TINA GUO - STORM CELLO

CAMPAIGN BOOK
THE CROW HILL COMPANY 2024

Feedback notes to GUI designers

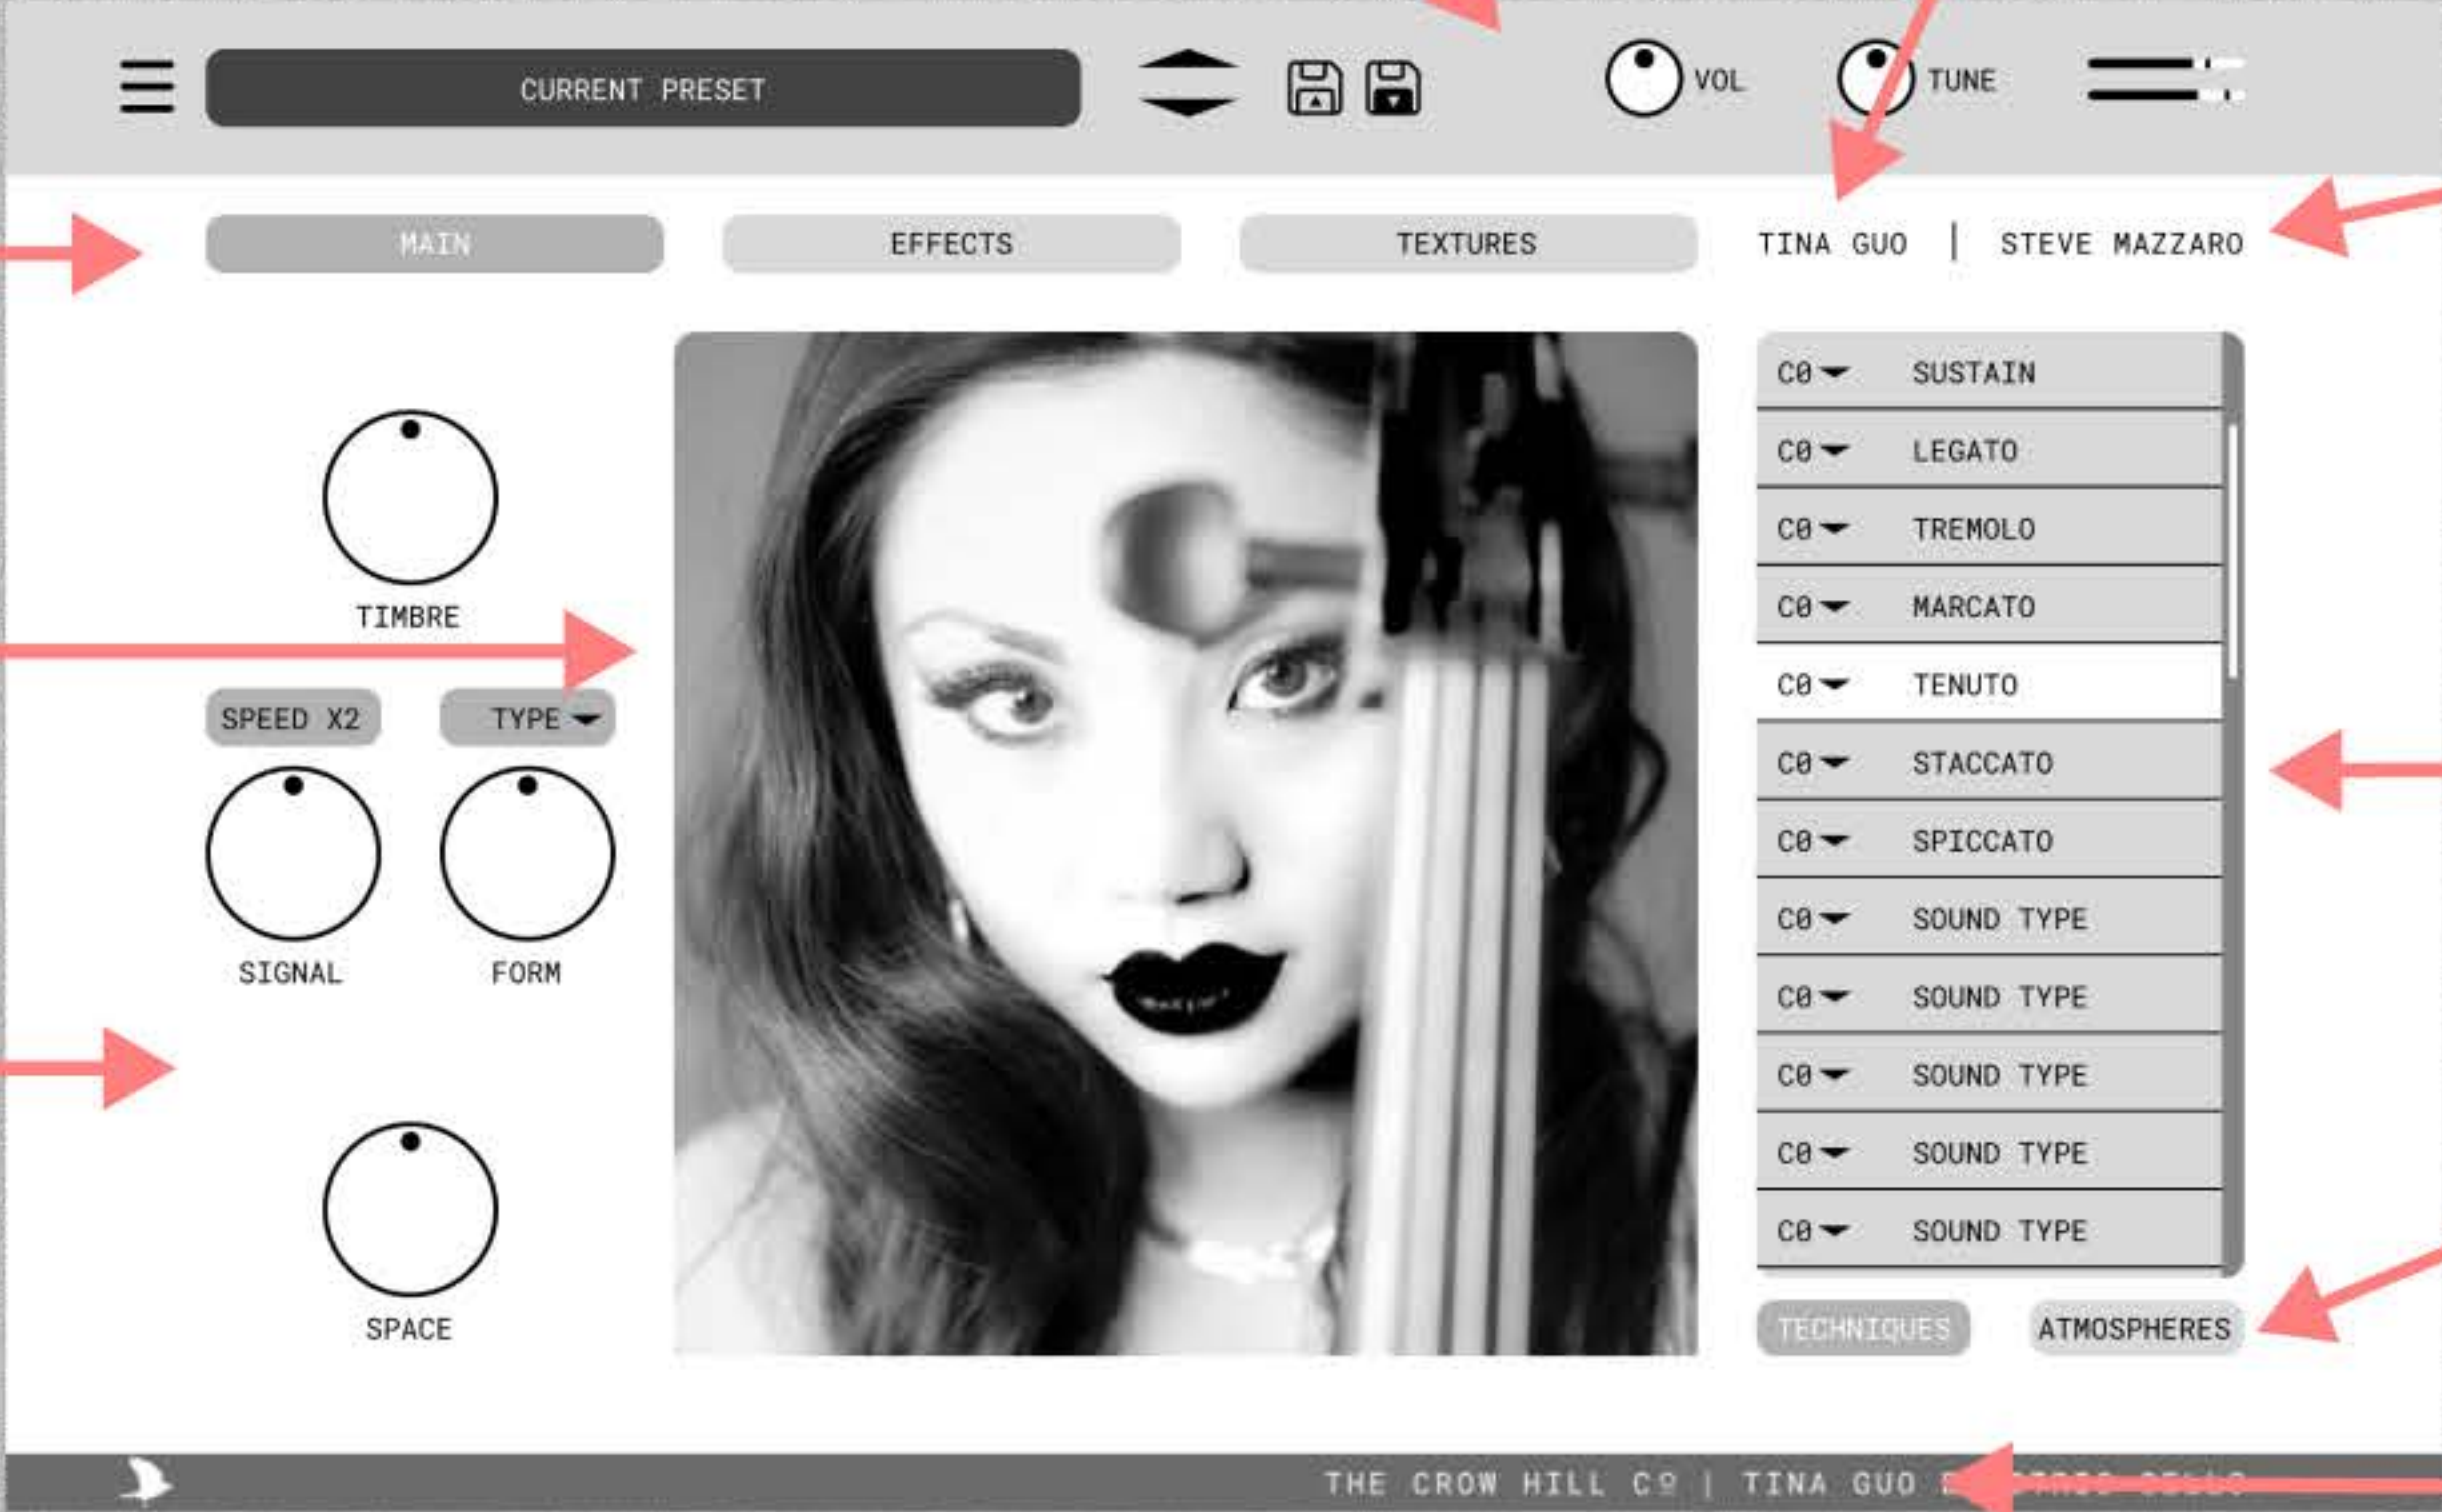
Overall "Top Bar" eats into overall layout. Could be slimmer or more integrated.

Utilise more obvious "Tina Guo" branding and identity

Remove Steves name

Use icons to assign pages. This will free up UI space and lessen text heavyness.

This concept will need to be explained to us in more detail. As mentioned before we would like to avoid the use of photography as we are yet to see this done "well" and can age an interface. The idea we discussed was use of a 3D model to integrate Tina into the interface, for instance as a stone or marble bust into the interface as earlier pictured. Curious to hear the designers thoughts and vision here.

Revert main controls to 1 per corner. It felt more modern and less forced.

I am open to the idea of these key controls being icon based instead of dials, designers choice.

An example would be looking at our piano or the strings you just did which used shapes and designs to portray value. But open to dials too.

Feels stronger as a central component, keeping it as the core focus?

"Textures"
These are tabbed pages for the scroll box above, I feel they could be integrated more into that. UX would lead me to feel they should be at the top, but depends on integration

Move this as a left-most "book spine"
